**SH2: Baypark to Bayfair,  
Tauranga**

**ROAD SAFETY AUDIT  
of the  
50%-85% DETAILED DESIGN**

A REPORT PREPARED FOR  
NZ TRANSPORT AGENCY

Reference 11180  
October 2017

Figure 1 – Dynamic sign showing speed and slow down message

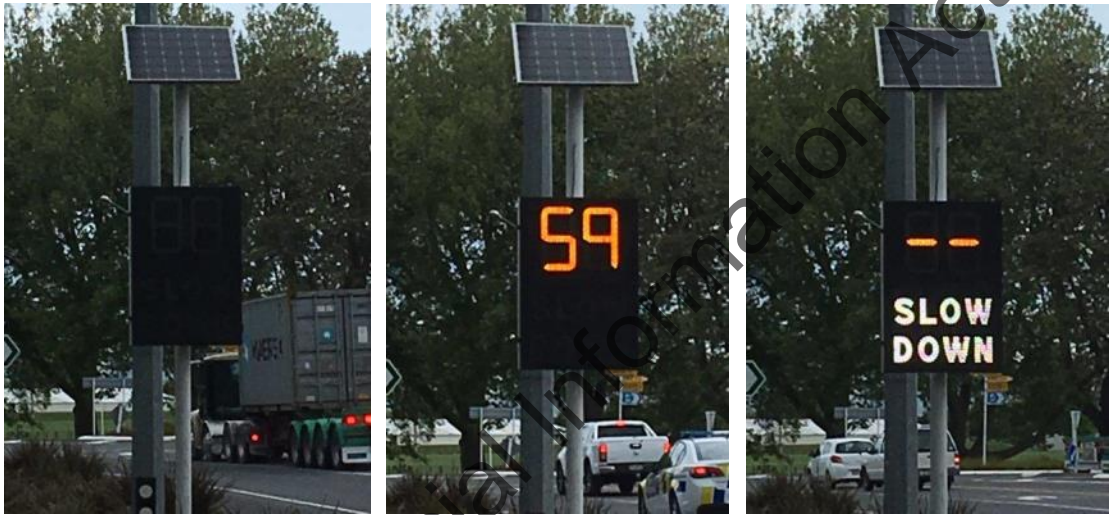
Speed management measures not only apply to thresholds (refer to item **2.2**) and include repeat speed limit signage as shown on the traffic services drawings, but should also include dynamic/electronic speed signage which advises drivers of their speed and includes a message to slow down (see **Figure 1**). An alternative sign is one that reinforces the speed limit when it detects a vehicle exceeding the speed limit (see **Figure 2**).

<b>Designer Response:</b>	<p>a. We have provided a geometric design that provides for an 80kph design speed environment in accordance with the PR and this is normally suitable for posted speed limit of 70kph. To implement a 80km/h speed limit (posted speed) would normally require a 90km/h design speed. To implement a 90km/h design speed would require significant re-design and threaten designation. We are conflicted with non-compliance with the PR's to address the Road Safety Audit comments. NZTA to advise.</p> <p>b. Dynamic/electronic speed signage can be installed on SH2 northbound, however, this is outside of project scope and NZTA to advise on provision.</p>
<b>Safety Engineer:</b>	<p>a. Under the Settings of Speed Limit Rule 2017 to change to a 70km/h speed limit needs the specific approval of the General Manager, Safety and Environment, NZ Transport Agency.</p> <p>Agree with the safety audit's team recommendation regarding having a section of lowered posted speed limit between the 100km/h TEL expressway and the 70km/h SH2 Maunganui Road section (it is expected near the completion of the Baylink project that consultation will be undertaken on lowering the speed limit on SH2 Hewletts Road and SH2 Maunganui Road to less than 70km/h).</p> <p>However, any change in speed limit will need to demonstrate a change in the road form and/or surrounding environment to reinforce what the safe and appropriate travel speed is for that particular section of road.</p> <p>b. There may be merit in installing dynamic/electronic speed signage to reinforce the safe and appropriate travel speed if has not been able to be reinforced by the design of the road form or the surrounding environment. The Contractor's design should not preclude the installation of these signs and associated ducting and infrastructure works post construction should it be considered that these are required.</p>
